Subject: Blackbuck Resources, LLC; Allegiance Federal SWD #1 (SWD-2677; pEG2528351636)
C-108 Supplemental Submittal

The purpose of this letter is to submit supplemental information associated with Blackbuck Resources, LLC's (Blackbuck) C-108 application for the proposed Allegiance Federal SWD #1 (SWD-2677; pEG2528351636). This information is being provided to address OCD's comments in a recent Administrative Completeness Checklist. A list of the updates to the application is included below.

Allegiance Federal SWD #1

Proposed Wellbore Diagram

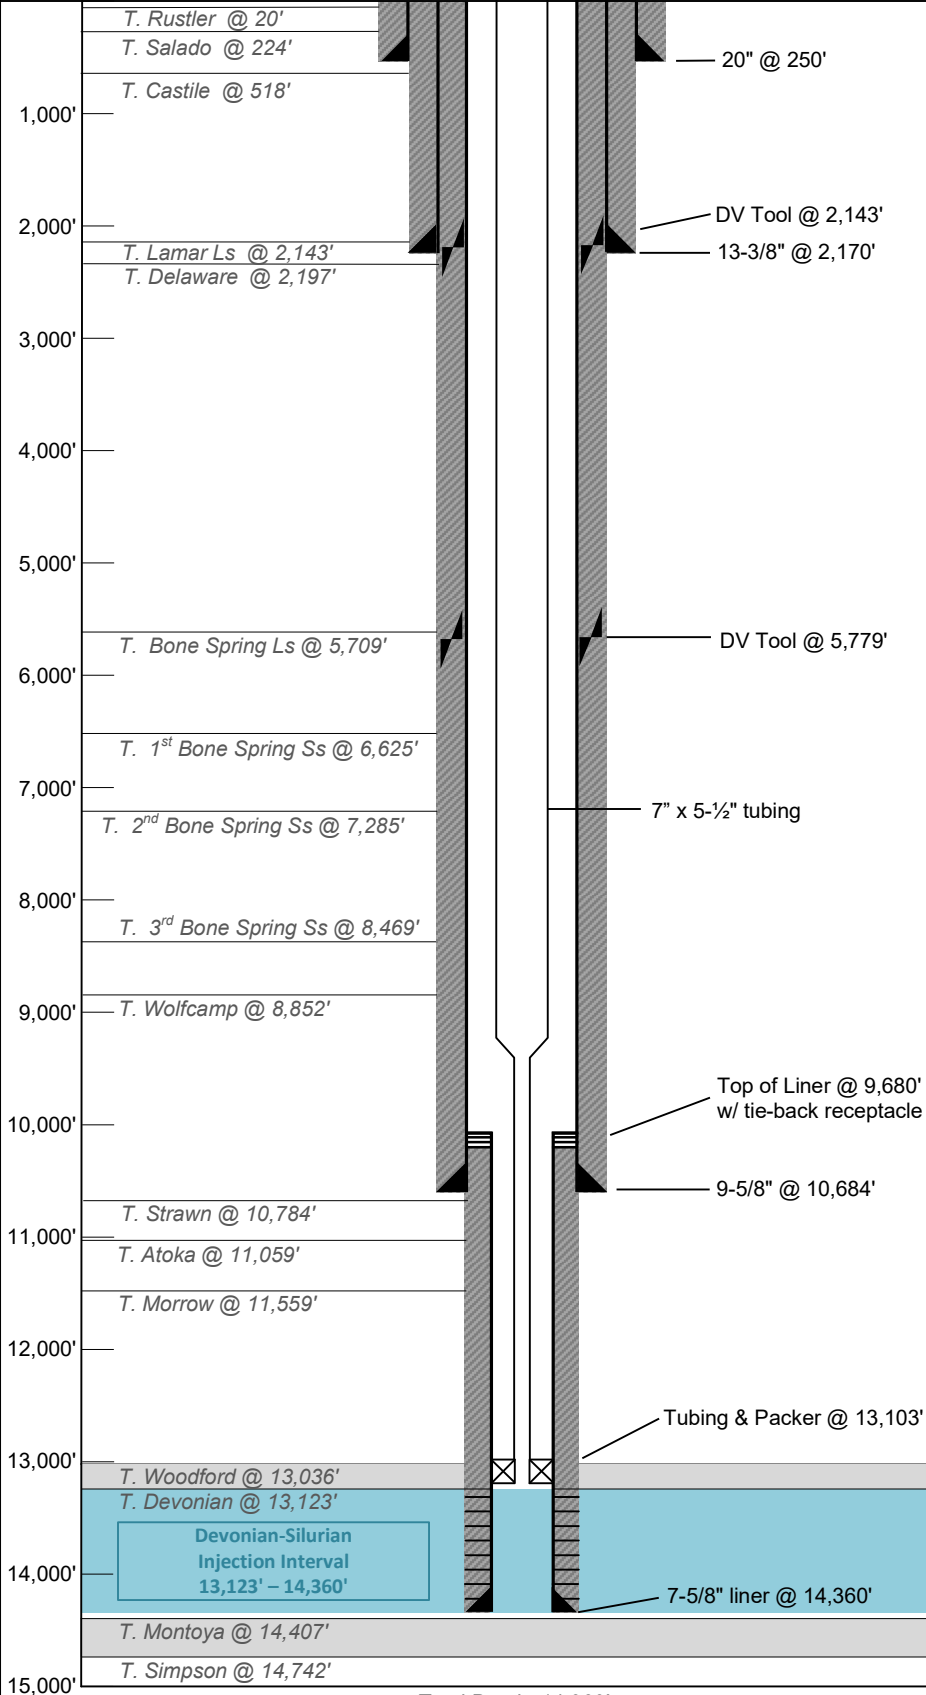
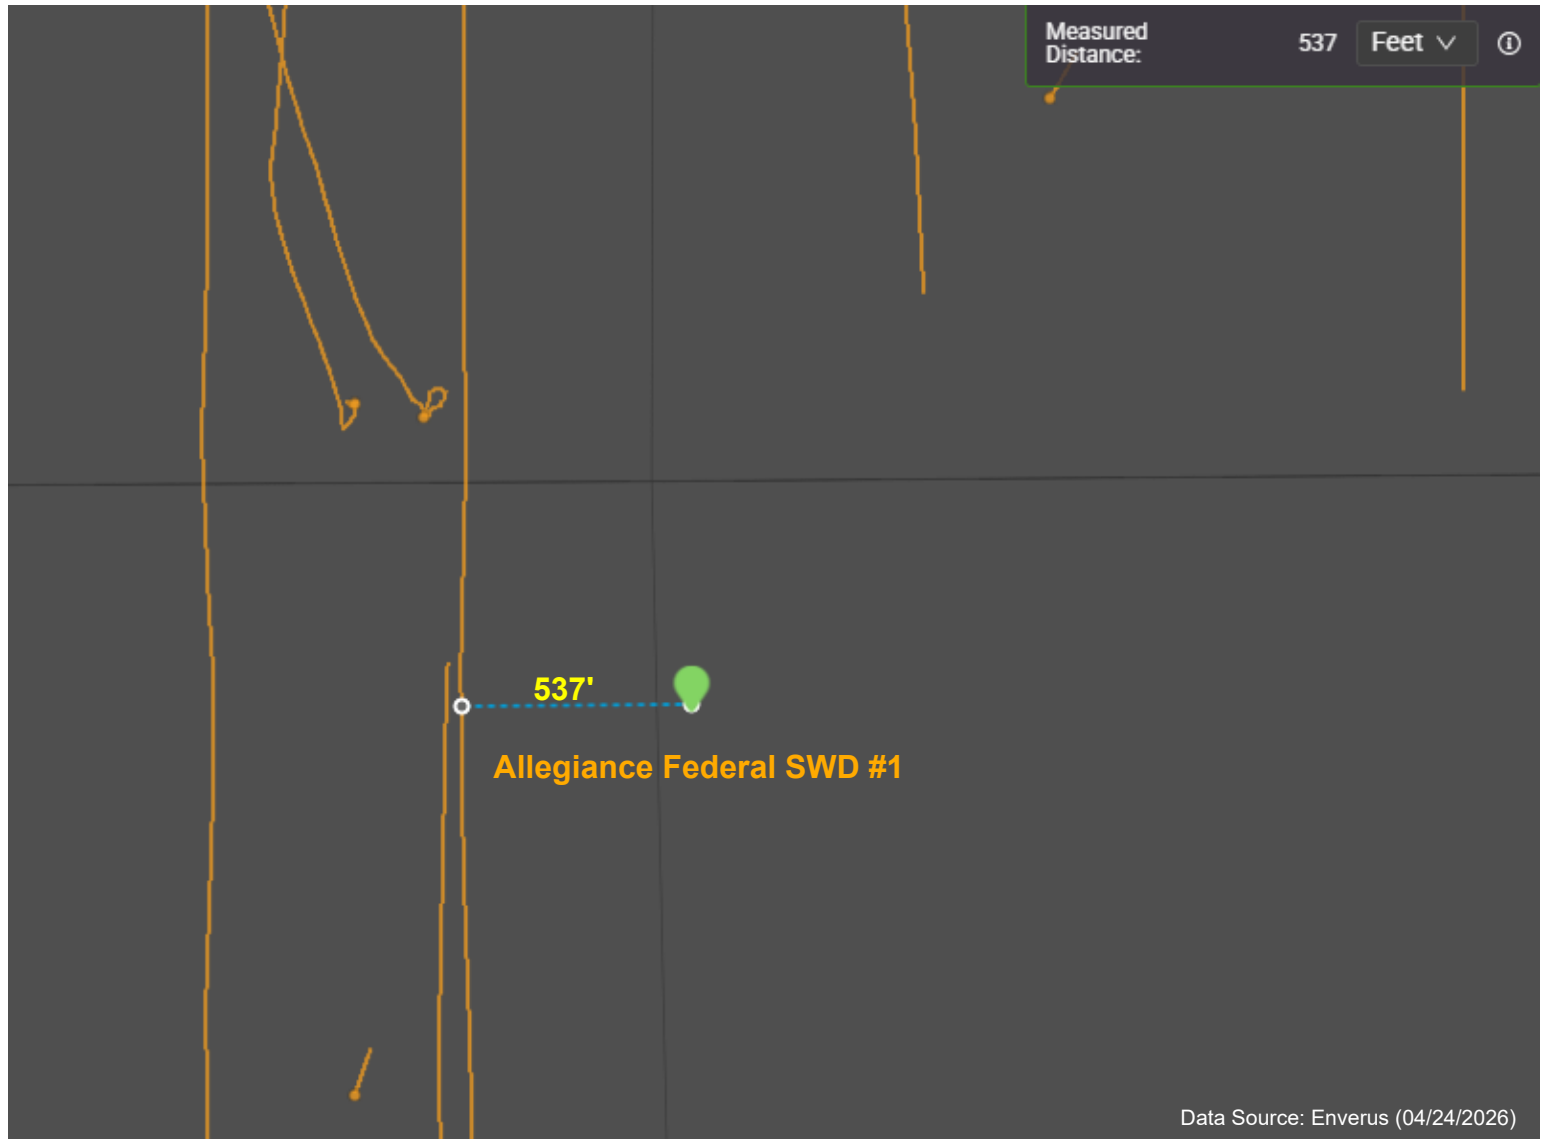
- **Revise from Open-Hole to Cased-Hole:** Revised completion from Open-Hole to Cased-Hole and updated the liner depth and cement volumes in the Tabulated Casing Data and Wellbore Diagram (WBD) accordingly.

- see **Attachment A** for Updated Tabulated Casing Data (p. 3) and Updated WBD (p. 5)
- **No Underlying USDW Statement:** Added a Statement to the Geology Data clarifying that "No USDWs were identified underlying the proposed injection interval."

Casing Size: 7-5/8 in
 Casing Type: 29.7 lb/ft HCL-80
 Casing Depth: 9,680 ft – 14,360 ft
 Hole Size: 8-3/4 in
 Top of Cement: 9,680 ft
 Sks Cement: 344 sx
 Cement Type: Class C

Formation(s): Devonian-Silurian
 Top: 13,123 ft
 Bottom: 14,360 ft
 Hole size: 7-5/8 in
 Cased or Open-Hole: Cased-Hole

Wellbore Diagram

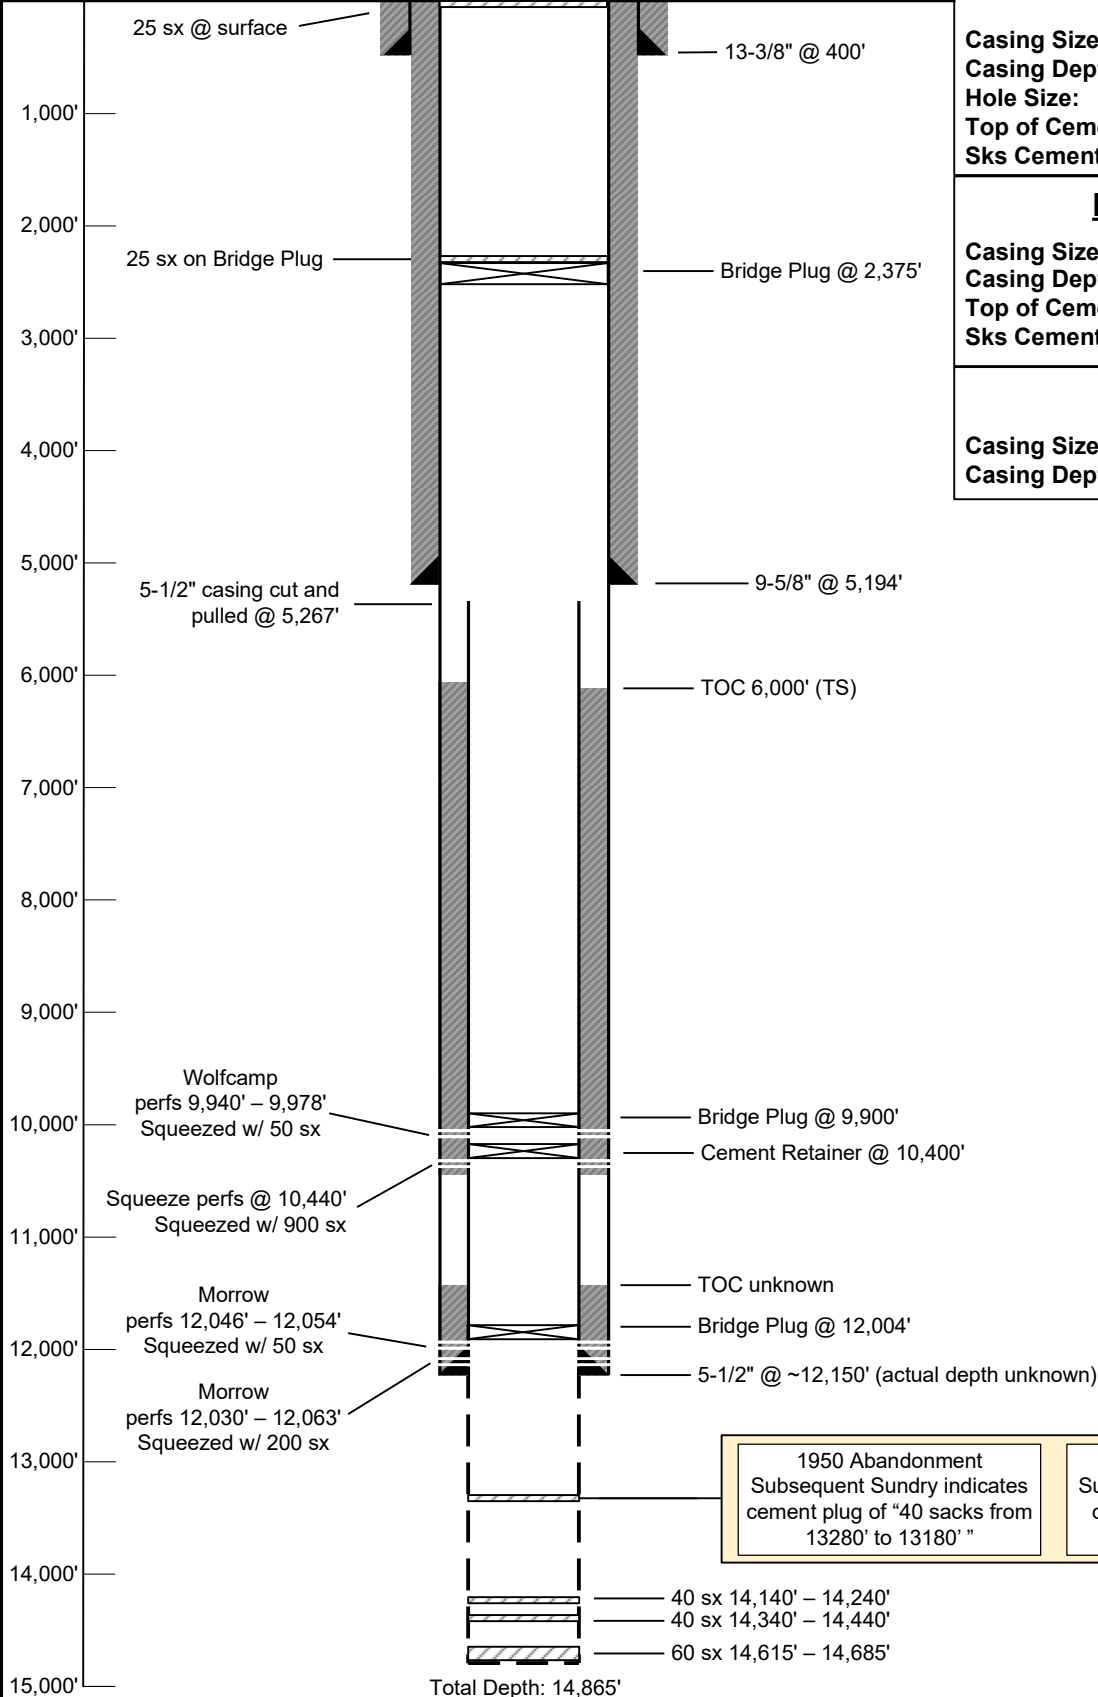
- See **Attachment B** for Horizontal Wellbore Proximity Map (p. 7)
- **Plugged Wellbore Diagram:** Prepared a Wellbore Diagram for API # 30-015-01137 (along with supporting documentation), which was identified as a well within the AOR that penetrated the injection interval.

- See **Attachment C** for Plugged WBD (p. 9) and Supporting Documentation (p. 10-19)
